Site Instruction

Project Name: AQUAVISTA - Bayside
Client: TRIDEL Corporation
To: TRIDEL Corporation
Attention: Chadi Loza
Fax number: -

Project No.: 8489D
SI No.: E 008
Page No.: 1 of 1+ 2 Attached
Office: Toronto
From: Sunanda Perera
Tao Li

Title: Relocate Mechanical Equipment Power Connection/ Miscellaneous clarifications.

N.T.S.
 Author: [Signature]
 Checked by: [Signature]
 8489D
 Date: 10/14/15
 Drawing No: E4-02

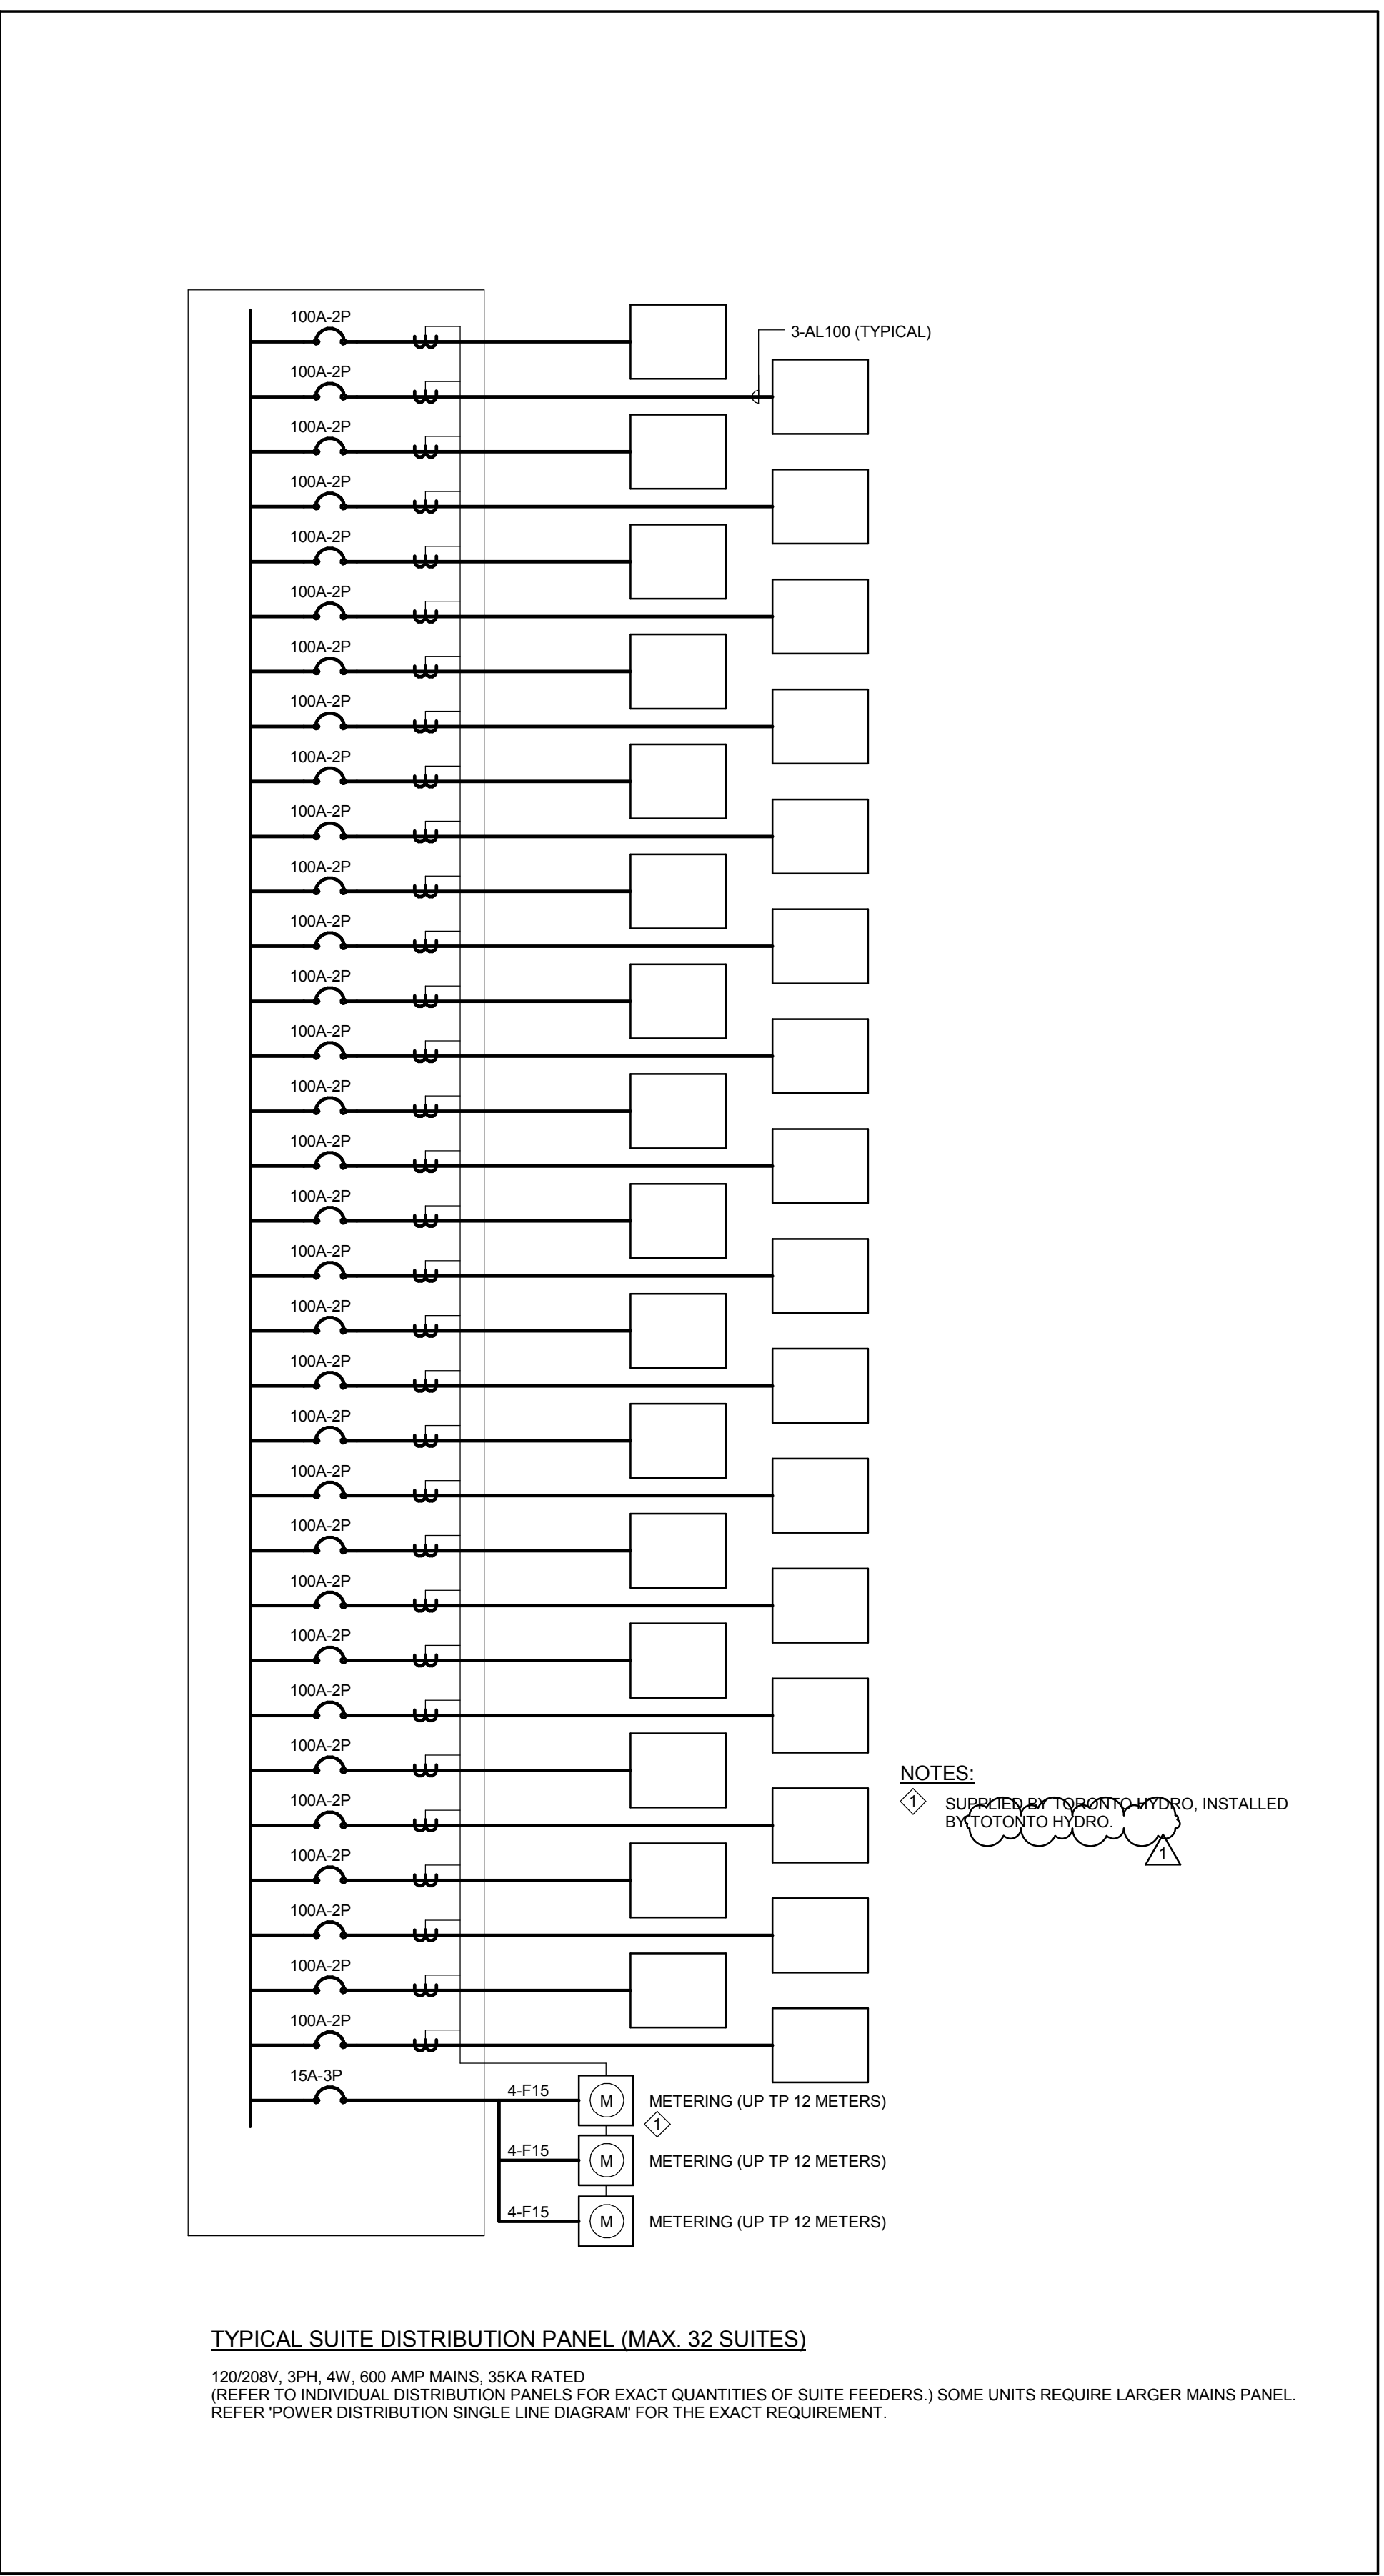
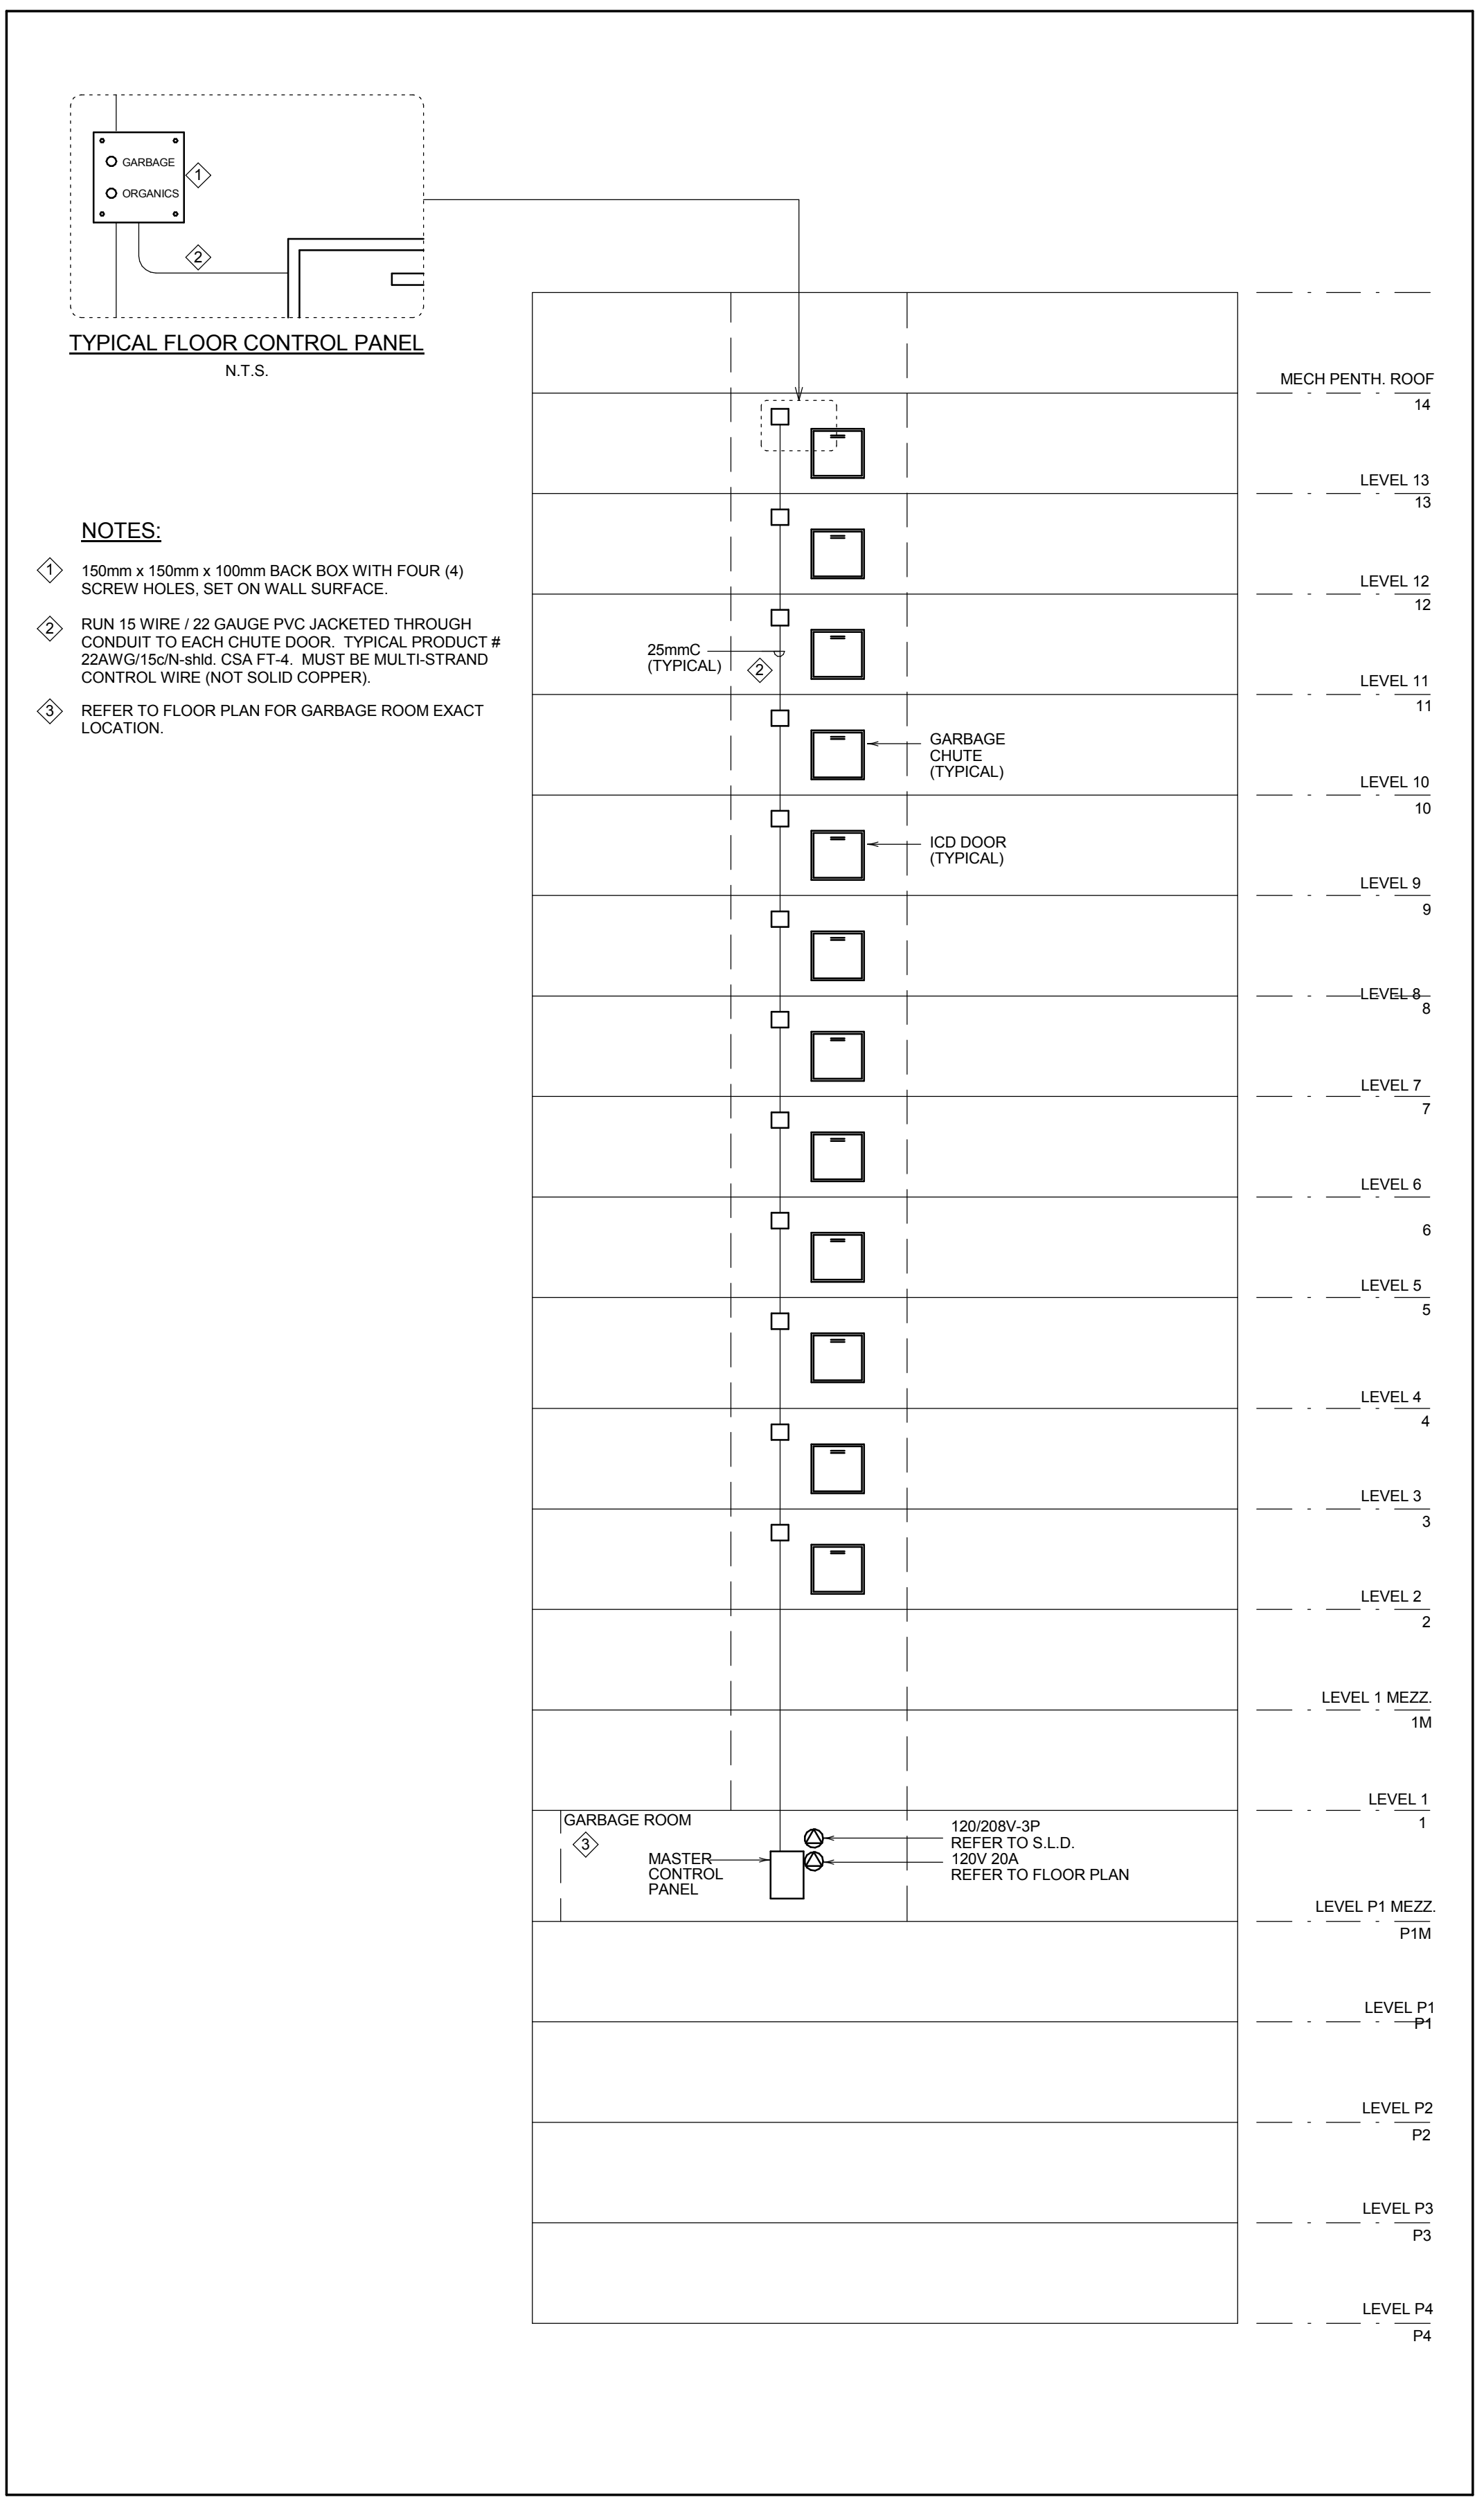
Drawing No.	Drawing Issued	Items
E0-01	No	Clarification for exit lights – Two exit signs shall be provided where bi-directional is shown on the location. Refer to the Legend for detail.
E1-02	Yes	Relocate power connections for ACUC-14/15/16 as shown.
E4-02	Yes	Revise note #1 on detail-7. 'Suite meter supplied by Toronto Hydro, installed by Toronto Hydro.'
